### MEMORANDUM

**SUBJECT:** SP20-131 Site Plan – Planning Review 2

**LOT 6 PARKER AND PINE FILING 1**  
 PARKER, CO  
 EVERBROOK ACADEMY SITE PLAN  
 SITE PLAN

LOT 6 PARKER AND PINE FILING 1  
 PARKER, CO  
 EVERBROOK ACADEMY SITE PLAN  
 LANDSCAPE PLAN

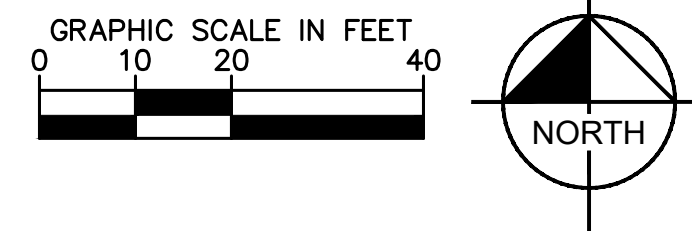
It appears tree can fit here outside of utility easements. Provide documentation if not possible.

Label what is adjacent to for each facade.

Street trees provided by Overall developer under separate permit. Sight triangles and existing utilities prevent additional trees.

Street trees provided by Overall developer under separate permit. Sight triangles and existing utilities prevent additional trees.

MANY OF THE ISLANDS CANNOT HOLD TREES DUE TO UTILITY CONFLICTS. TREES PLACED WITHIN LANDSCAPE MEDIAN FOR PARKING LOT COVERAGE WITHOUT UT CONFLICTS

PERCENTAGE UPDATED

CALCULATION UPDATED

ACKNOWLEDGED AND CONFIRMED

TREE CAN NOT BE PLACED HERE DUE TO UTILITY CONFLICTS (STORM PIPE)

**LOT 6 PARKER AND PINE FILING 1**  
 PARKER, CO  
 EVERBROOK ACADEMY SITE PLAN  
 ARCHITECTURAL ELEVATIONS

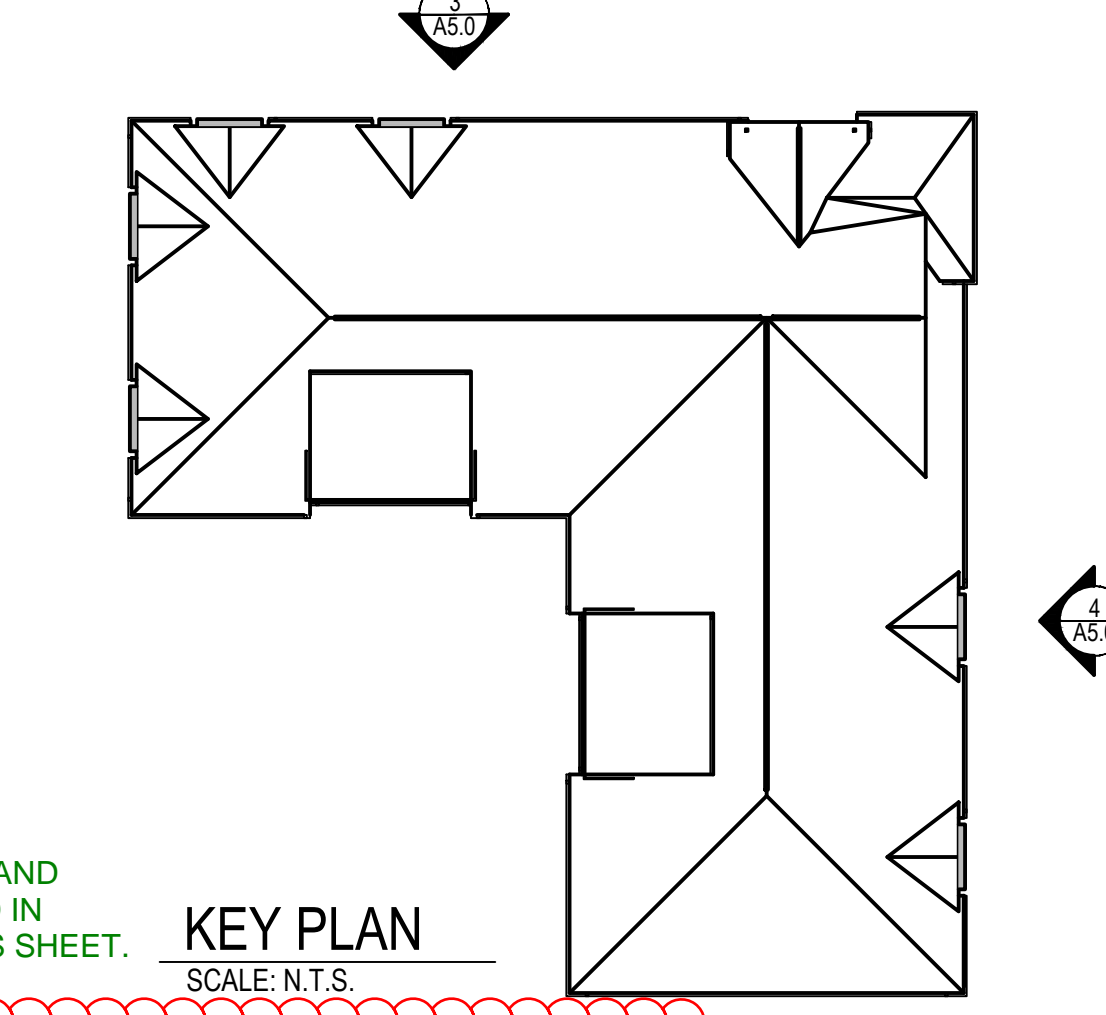
Move to next page.  
 Delete this page.

**RESPONSE: SHEET WAS DELETED AND CHART WAS INCLUDED IN COLORED ELEVATIONS SHEET.**

**RESPONSE: ADD ROW FOR REQUIRED TRANSPARENCY. SEE REVISED COLORED ELEVATIONS SHEET**

**LOT 6 PARKER AND PINE FILING 1**  
 PARKER, CO  
 EVERBROOK ACADEMY SITE PLAN  
 ARCHITECTURAL MATERIALS BOARD

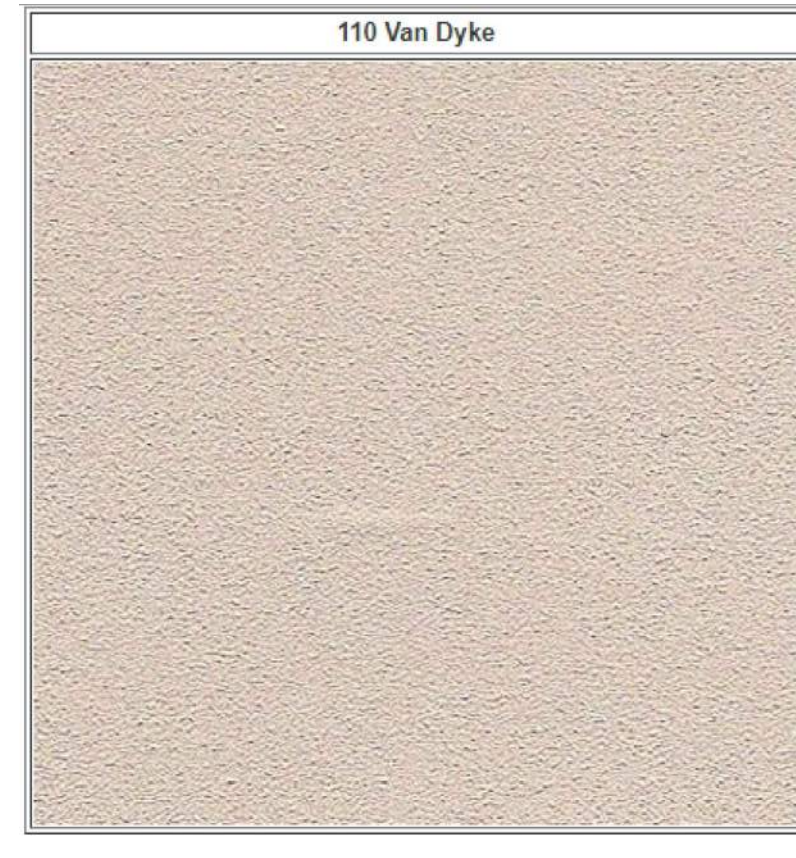
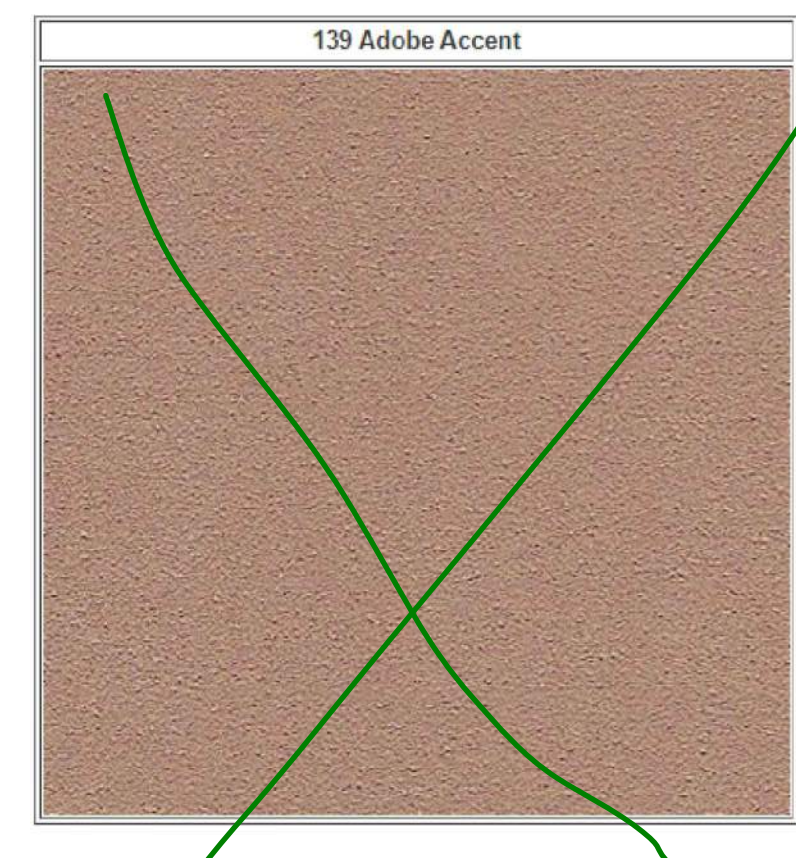
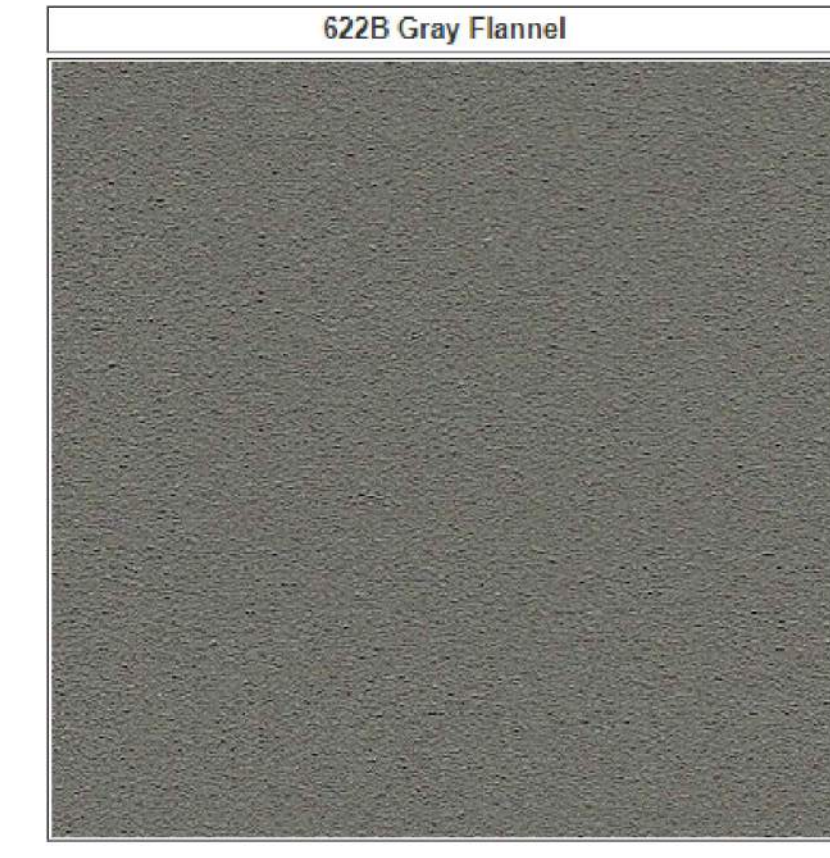
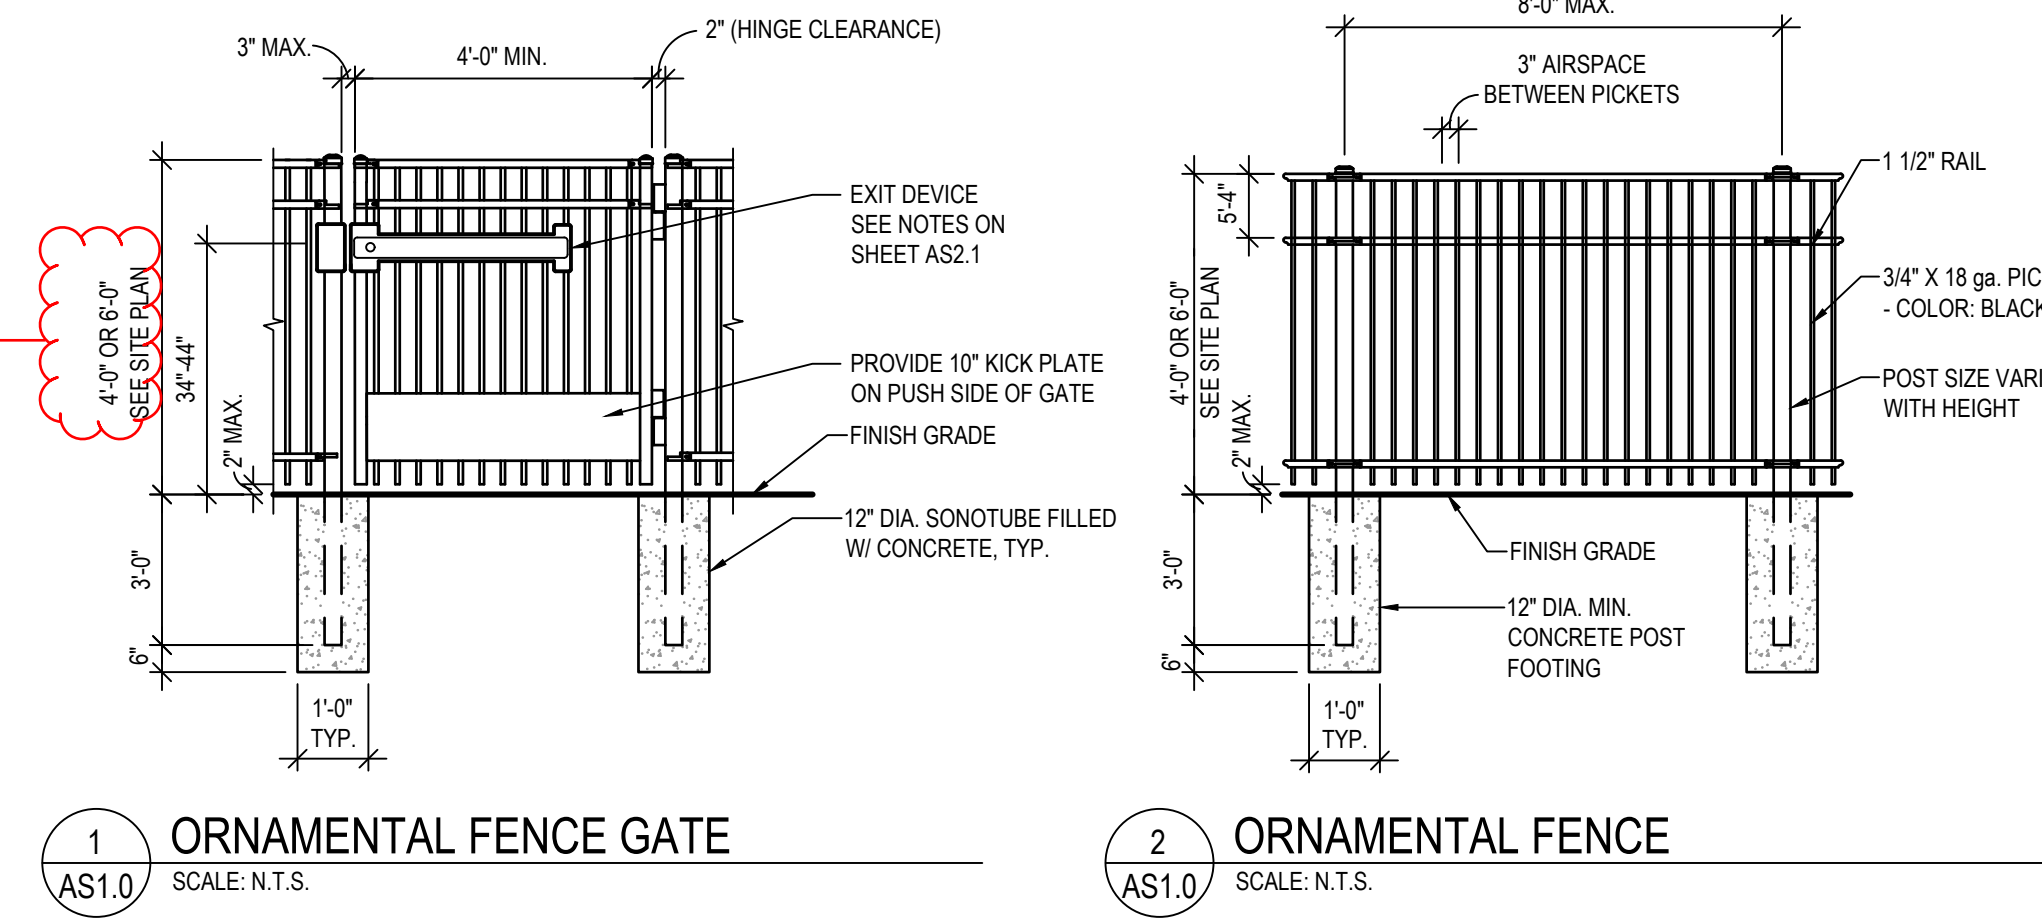
RESPONSE: CLARIFIED THAT MOST FENCES ARE 6' HIGH. ADDED A SEPARATE 4' HIGH FENCE DETAIL.  
 Where fence is 4 foot and where it is 6 foot is not clarified on site plan.

Provide awning detail. Label color.

There is no additional sheet with retaining wall elevations per greenline note.

There is no sheet provided addressing comments. All comments should be addressed in greenlines and additional labeling should be added to site plan set.

Provide frame material to ensure compliance with PD guidelines, as requested in last comment.

Label as black or grey per PD guidelines.

No swatch of grey provided as requested. Material no longer part of description. Must be metal per PD guidelines.

RESPONSE: added product spec and typical photo to this sheet

RESPONSE: REFER TO ADDED ELEVATIONS

RESPONSE: ADDRESSED ALL COMMENTS

RESPONSE: CLARIFIED THAT STOREFRONTS ARE ALUMINUM

RESPONSE: THESE ARE HALLOW METAL (H.M.) DOORS. HAVE COMPLIED WITH PD GUIDELINES.

**1 PHOTOMETRIC PLAN**  
12 OF 13 SCALE: 1/16" = 1'-0"

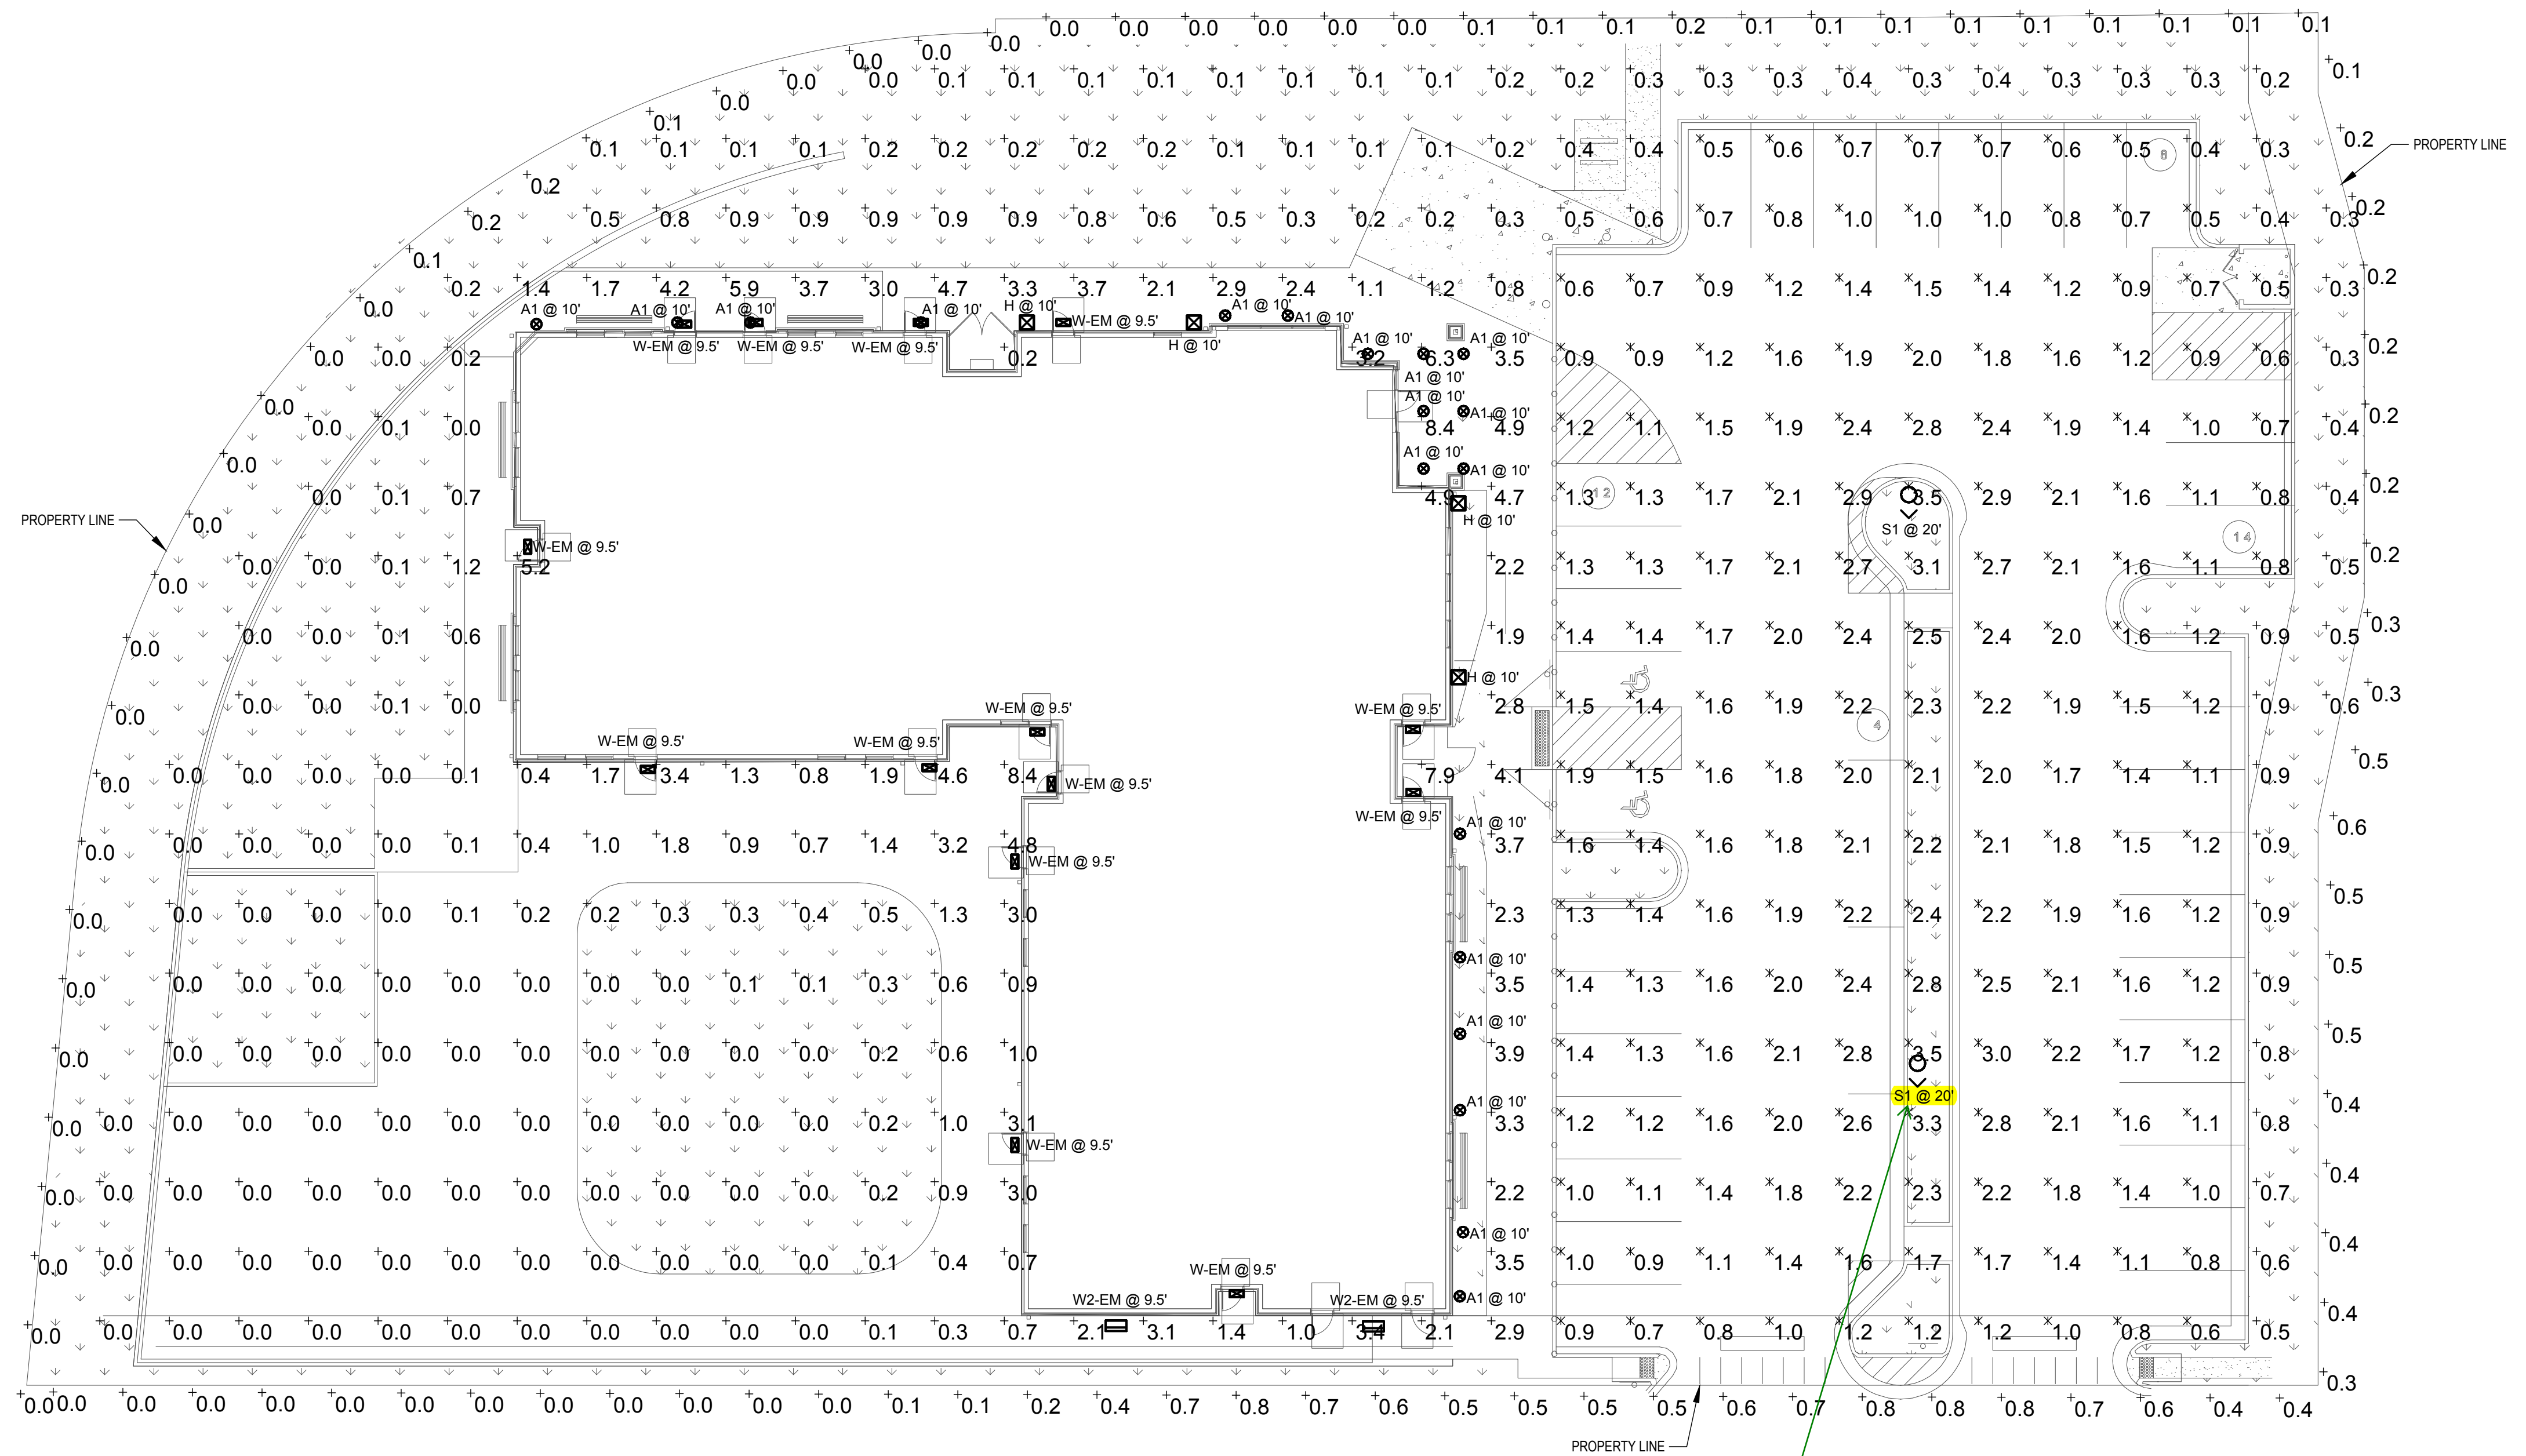
Add sheet note: All parking lot lights, except those required for security as provided herein, shall be extinguished within one (1) hour after the end of business hours and remain extinguished until one (1) hour prior to the commencement of business hours.

Make fixture color not black so can see on photometric plan.

RESPONSE:  
NOTE WAS ADDED.  
SEE REVISED SHEET.

RESPONSE:  
THIS DESIGNATION IS CORRECT AND COORDINATED WITH THE CUT SHEET ON THE NEXT SHEET.

RESPONSE:  
HIGHLIGHTED THE FIXTURE DESIGNATIONS FOR YOUR CONVENIENCE.
